From: Simon Bareham <simon.bareham@lewisplanning.co.uk>
Sent: 21 July 2025 12:00:32 UTC+01:00
To: "Anna Tidey" <anna.tidey@midsussex.gov.uk>
Subject: RE: Barn 1 - Amended Plans for Application DM/25/1024 - Providence Farm, Colwood Lane, Warninglid

From: Simon Bareham <simon.bareham@lewisplanning.co.uk>
Sent: 21 July 2025 09:02
To: Anna Tidey <anna.tidey@midsussex.gov.uk>
Subject: RE: Request for Amended Plans/Follow up to site visit for Applications DM/25/1024 and DM/25/1025 - Providence Farm, Colwood Lane, Warninglid

Subject: FW: Request for Amended Plans/Follow up to site visit for Applications DM/25/1024 and DM/25/1025 - Providence Farm, Colwood Lane, Warninglid

FRFC_Wrngld_04_BR_EX_02

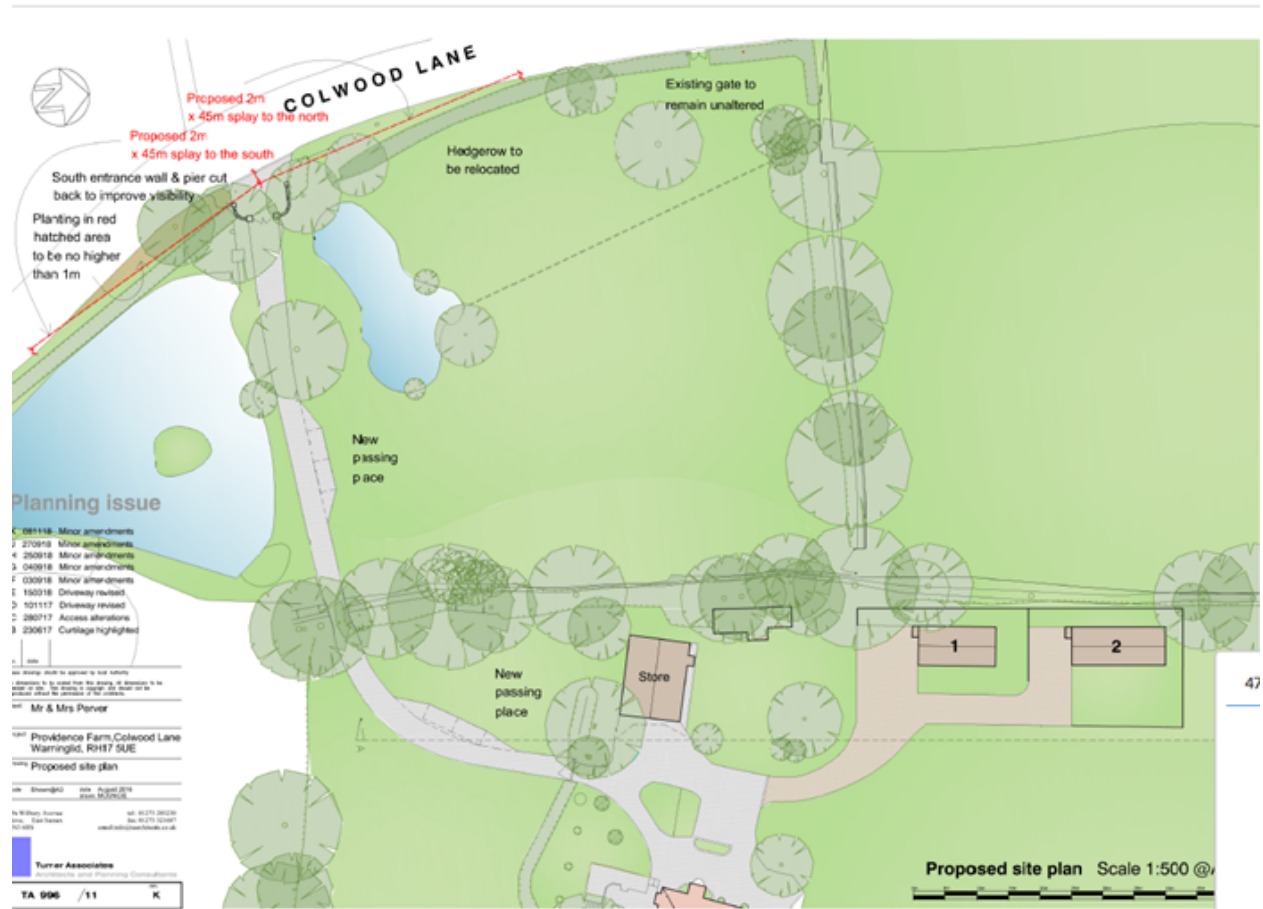
I am working on my reports for DM/25/1024 and DM/25/1025 this afternoon. Unfortunately I shall be unable to recommend the applications are approved as they both include Location Plans that show a red line extended around a second separate vehicular access point to serve the barns, which has not been approved. For your information please see the access plans below.

As submitted for DM/25/1025 – for Barn 2 - Existing/as built elevations, Sections and Plan – Drawing ref FRFC_Wrngld_04_BR_EX_02:

In order to take the applications forward to a positive recommendation I shall be grateful if you can please provide a revised Proposed Elevations and Location Plan with the red line to accord with the approved plan, see below.

A change to the front door at Barn 2 has also taken place, with a glazed door in place of an approved solid central door in the eastern facing elevation. **May I suggest that the Proposed Plans for DM/25/1024 (Drawing ref FRFC_Wrngld_04_BR_EX_02) is also amended to correctly reflect the works that have been carried out on site.**
